Preliminary Plan 120140170, Vassar Circle

Staff Report Date: 10/28/16

Description

FIRE DEPARTMENT ACCESS PLAN &
FIRE LANE SIGNAGE PLAN

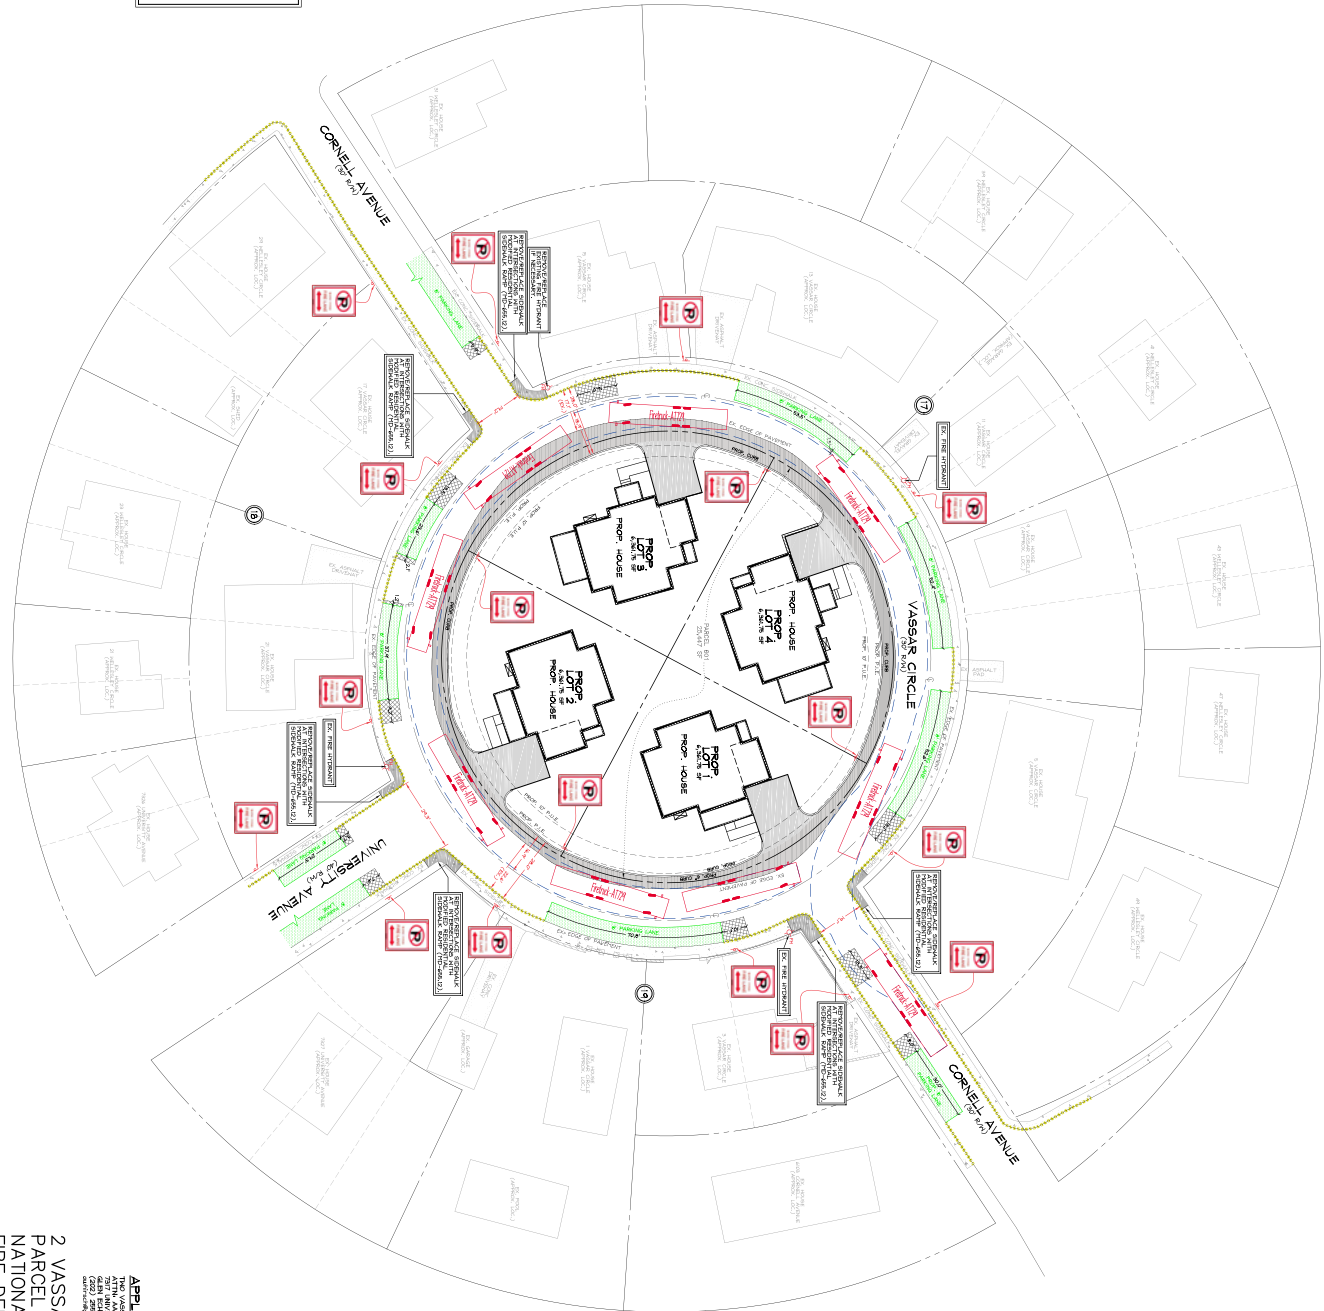
3. INACCURATE LABELING IN THE FIRE DEPARTMENT ACCESS PLAN.

The Fire Department Access Plan shows that there is no parking in front of 15 Vassar Circle. This is not correct; parking is allowed there. This may seem like a trivial error, but it is not trivial because that parking space occupies the narrowest point in the whole circle, and on its existence or non-existence rests the whole success of Applicant's claim that a fire engine can successfully negotiate the curve with no need to widen the roadway. As pointed out above, if a vehicle is occupying the parking space in front of 15 Vassar, a fire engine's clearance is from 7 inches to 27 inches.

Applicant's diagram gives the fire truck's width as 8 (eight) feet. In response to a direct question over the phone from a Vassar Circle resident, a spokesman at the Glen Echo Fire Department said that their fire engine was 9 feet 9 inches wide. Since the Fire Department operates a variety of vehicles of various widths, does the 8-foot width provided by Applicant represent the largest equipment that might necessarily be called in?

The Fire Department Access Plan shows that a parking space on upper Cornell Ave. is to be eliminated. We assume that this means that Applicant plans to ask the Fire Marshall to make parking there illegal. We also assume that Applicant plans to rely on the elimination of the potentially obstructive parking space in front of 15 Vassar. In view of the already limited parking on Vassar for current residents (about 2 curb spaces per house), and the lack of adequate overflow space on adjacent streets, it seems peculiar that Applicant would propose to address existing conditions by adding 66% more cars (12 cars in the proposed subdivision on a street with 18 spaces) while reducing existing spaces by 10% (eliminating 2 spaces out of the existing 19: 18 on Vassar Circle, 1 on upper Cornell Ave.).

Lot 2 Driveway

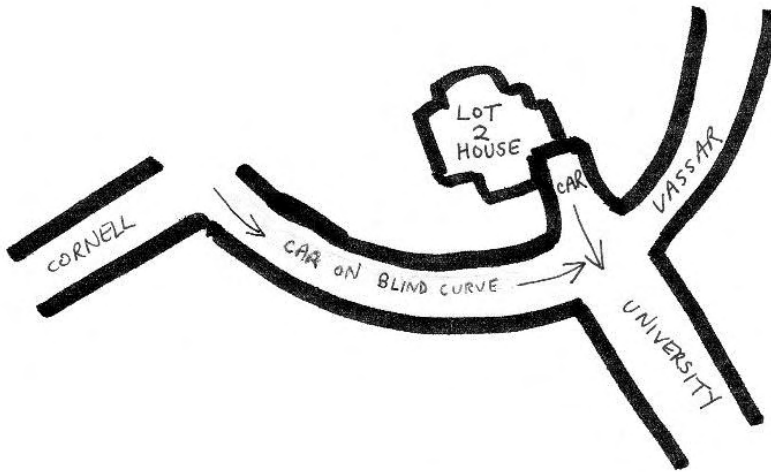
The lot 2 driveway will direct cars directly onto Vassar Circle at a point where visibility is impaired due to the blind curve already described.

The placement of the lot 2 driveway is more likely to result in a collision than was the placement of the old exit from the church parking lot because the old exit was slightly farther north of the intersection with University, was beyond the point where Vassar Circle becomes level with University, and was lightly higher in elevation, so that it gave the driver of a car exiting the church lot a better view of approaching cars.

Lot 3 Driveway

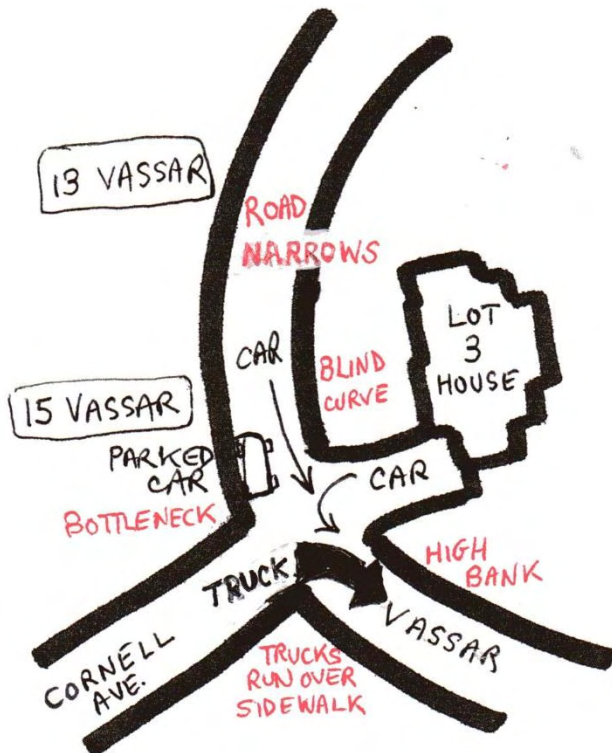
The lot 3 driveway would feed additional cars directly into an existing bottleneck where the roadway is at its narrowest.

A car coming out of the lot 3 driveway would emerge into the narrow roadway on a blind curve where a driver coming around Vassar would be unlikely to see it.
